**BIG HORN COAL COMPANY  
10980 SOUTH JORDAN GATEWAY  
SOUTH JORDAN, UT 84095**

January 25, 2017

**RE: Objections to Proposed Brook Mine Permit Application, Sheridan County, Wyoming**

BHCC Objection No. 4 Attachment 1

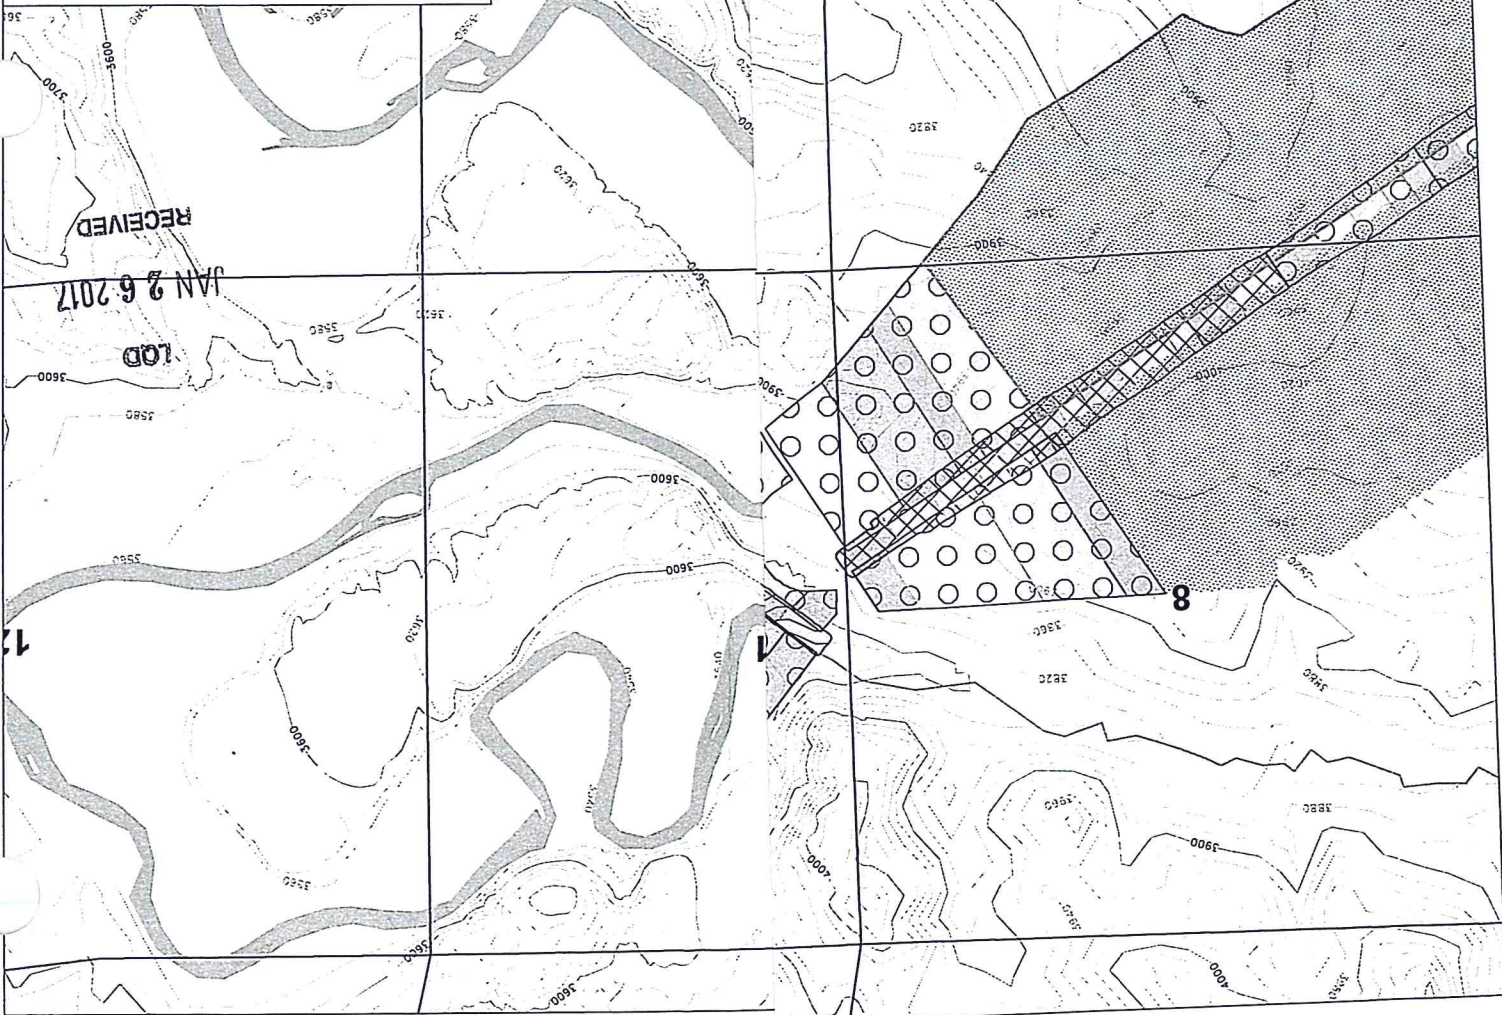
Attachment 1 provided with this Objection No. 4 is a drawing showing the approximate extent of underground coal mine fires in the area of proposed highwall mining in Sections 10 and 15, T57N, R84W, as reported by the U.S. Geological Survey in 1980. The fires in this particular area originated with mining of the Monarch coal. This and other nearby historic underground mines have long been known to exhibit numerous subsidence features and underground coal mine fires, and in the late 1980s BHCC received approval from the WDEQ/LQD to permanently place nearly 10 million bank cubic yards of overburden over the area shown on Attachment 1 in an attempt to reclaim the subsidence and control the fire. That unique reclamation feature is known as the Pit 3 Subsidence Dump in Big Horn Mine's reclamation history. The proposed highwall mining will develop mine openings in the Carney and Masters coal seams beneath the Monarch seam in areas that are known to still exhibit evidence of underground coal fires. Plumes of steam and smoke have been observed again over the general area of Sections 10 and 15 this winter of 2016-2017. These observations indicate that, in places, the perimeter of the historic subsurface coal seam fires has expanded notable distances from the referenced 1980 boundary delineation.

The subsidence control plan of Addendum MP-6 does little to guarantee the long-term protection of BHCC's surface estate especially where highwall mining panels will be driven beneath underground coal mine fires having a long history of activity. Section MP-6.2 of Addendum MP-6 provides numerical calculations for subsidence chimney heights, but there is no investigation of the potential that the historic mine fires may have compromised the structural integrity of strata underlying the fires and overlying the coals targeted for highwall panel mining (the interburden), leaving the interburden more prone to subside than normal. BHCC is particularly concerned and objects to highwall mining beneath or adjacent to pre-existing underground mine fires because of the potential for oxygen and water to be transmitted from the highwall mining openings to "hotspots" in the seams already burning via highwall trenches or via fractured or subsided interburden above the panel openings. BHCC strongly disagrees with the legitimacy of the plan stated in Section MP-6.4 of Addendum MP-6 which states "Backfilling will also be performed if it is determined that the introduction of water and oxygen could contribute to spontaneous ignition of the remaining coal not extracted from the highwall mining operations". BHCC

Objection No. 4 above introduces the fact that the underground mine fires in this area are still burning and have expanded. Section MP.15 does not, in any way, address that the burned areas have expanded. A surface mine excavation that comes in contact with a historic mine fire could be catastrophic in many ways, including: impacting the safety of mine workers, damage to equipment, wildfire initiation, etc. BHCC believes this mine plan has not adequately addressed surface mining activities that will occur near underground mines and insists that the Brook Mine operators must perform the necessary testing and analysis to prove that the proposed mine plan will not be impacted by historic mine fires. Specifically, attachment 1 provided with Objection No. 3 above shows that trench TR-2 is planned very near an area that was burning and is likely still burning. Given that the burned area has likely expanded, this area should not be disturbed at all.
